SUNDRY NOTICES AND REPORTS ON WELLS

8. Well Name and No.
EDITH FEDERAL #19. API Well No.
30-025-2885610. Field and Pool or Exploratory Area
N/A11. County or Parish, State
LEA, NEW MEXICO

Edith Federal 1

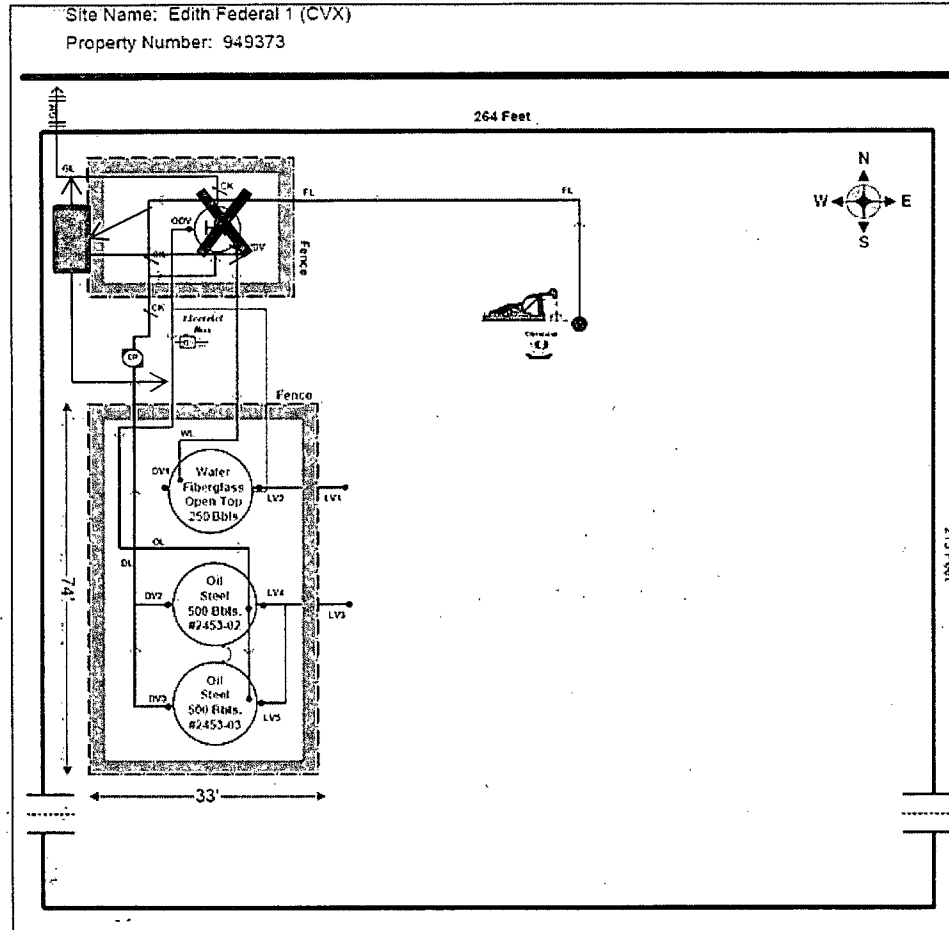
Due to High line pressure , we will add temporary 3 phase separator (denoted by blue square) to bypass the HT (denoted by the big X as bypassed). Once the line pressure is back to normal, we will remove the temporary separator and use existing facility. Like before. Expected duration of temporary solution is 6 months
